SUBJECT: BEAVER VALLEY UNIT 1 ISSUANCE OF AMENDMENT (TAC NO. 73604)

The amendment raises the maximum allowed service water (river water) temperature from 86°F to 90°F for Unit 1. The amendment also revises a number of requirements associated with this change.

Amendment No. 143  
License No. DPR-66

SAFETY EVALUATION BY THE OFFICE OF NUCLEAR REACTOR REGULATION

FIGURE 3.6-1  
 MAXIMUM ALLOWABLE PRIMARY CONTAINMENT AIR PRESSURE  
 VERSUS RIVER WATER TEMPERATURE

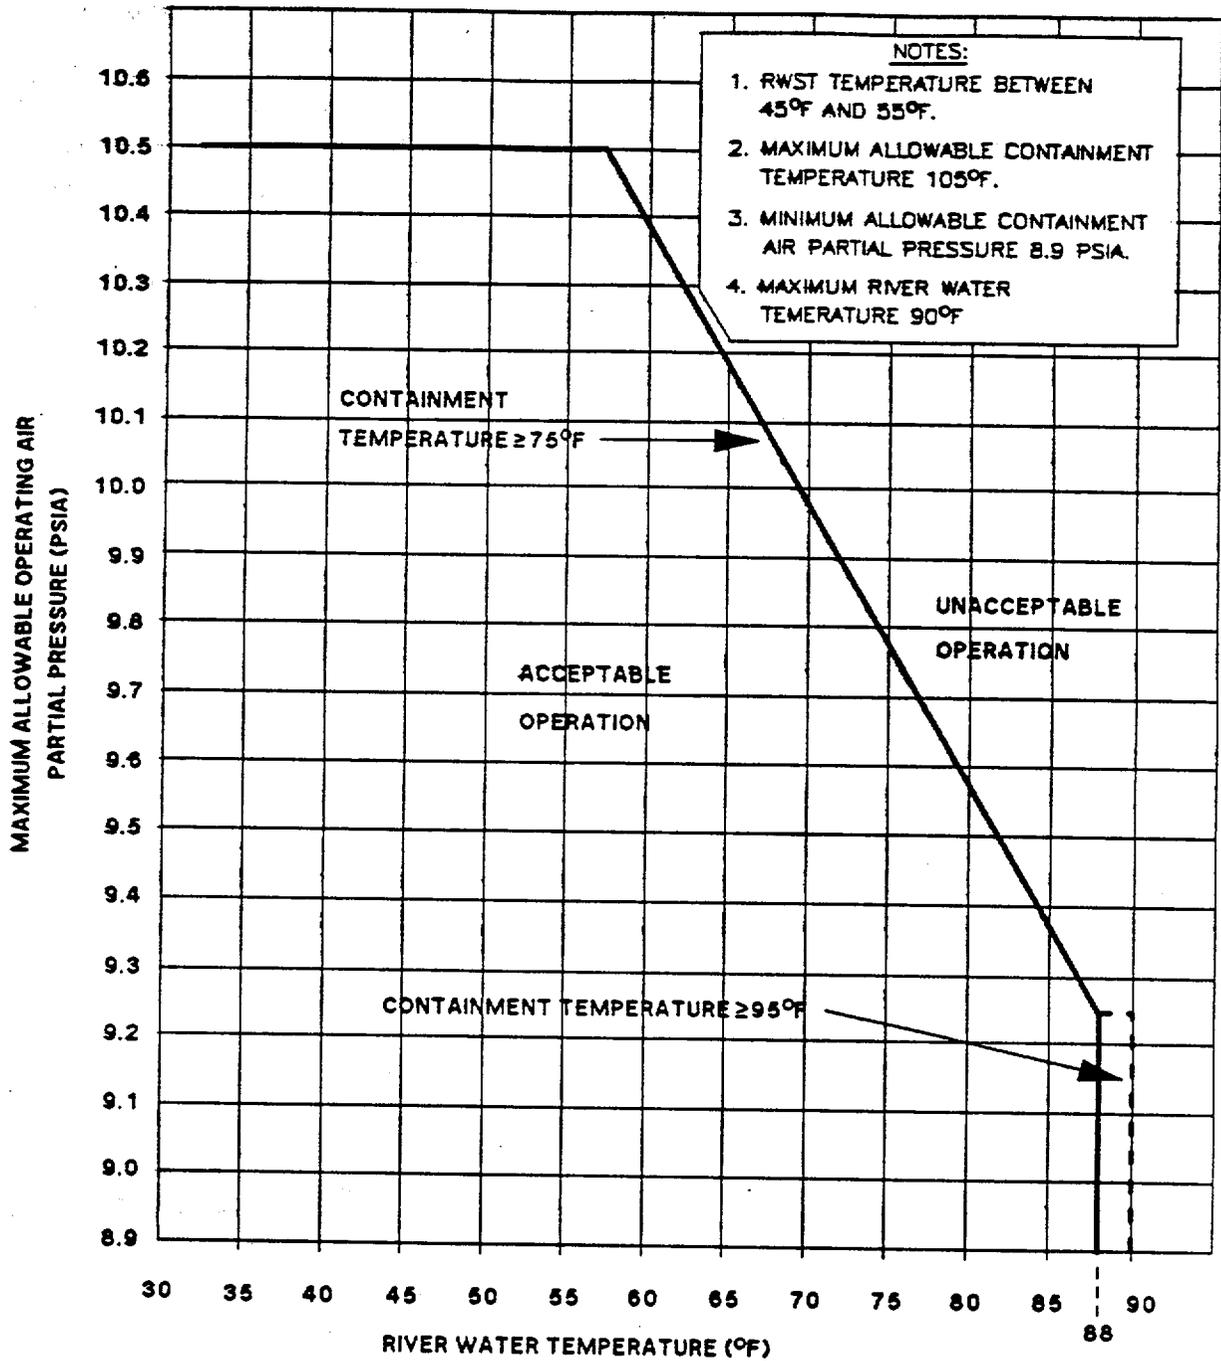
(4) Figure 3.6-1 and Specifications 3.6.1.4, 3.6.1.5 and 3.7.5.1

Figure 3.6-1, the maximum allowable Primary Containment Air Pressure versus River Water Temperature curve, has been revised to reflect the revised containment depressurization analysis based on a single RWST temperature limit and the increased river water temperature limit. The revised figure includes additional containment average air temperature restrictions when operating with river water temperature above 88°F as required to support the assumptions of the revised analysis. Technical Specification 3.6.1.4 and 3.6.1.5 for containment maximum air partial pressure and containment minimum temperature are revised to be consistent with the new Figure 3.6-1.

The licensee used the LOCTIC computer code to perform the reanalysis. The reanalysis took into account the following changes:

- a. Use of a single maximum RWST temperature (55°F)
- b. New RWST setpoints for spray recirculation and quench spray cutback were used (see change (6) below).

- c. Use of reduced containment net free volume (see change (3) above).
- d. Assumption of 10% degradation of rated head for the quench spray and recirculation spray pumps, in accordance with ASME Section XI, and addressing the licensee's SSFE concerns.
- e. Containment quench spray thermal efficiency is assumed to be 99% (95% was assumed in the licensing basis), and recirculating spray thermal efficiency is assumed to range between 99% and 95% (a constant 90% was assumed in the licensing basis). These are currently acceptable values.
- f. Use of ANS 5.1-1979 model for decay heat generation (previously, ANS 5.1-1971 was used).
- g. Reactor thermal power of 2733 MWT, i.e. licensed rating plus 2% uncertainty (previously, the ESF rating of 2766 MWT was used).
- h. Credit for steam condensation by safety injection during reflooding was assumed (previously not allowed).

The results of the licensee's analyses show that the Containment Depressurization System is capable of reducing the containment pressure to subatmospheric within 1 hour for river water temperature up to 88°F. Depressurization will still be attained in an hour if river water temperature was at 90°F or less and initial containment temperature at greater than 95°F. Thus no revisions need be made to accident evaluations in the unit's licensing basis. Furthermore, the reanalysis showed that NPSH requirements will continue to be satisfied for the low head safety injection pumps and recirculation spray pumps.

Based on satisfactory resolution of all the above considerations, we find the increase of service water temperature limits and the associated revised depressurization analysis acceptable.
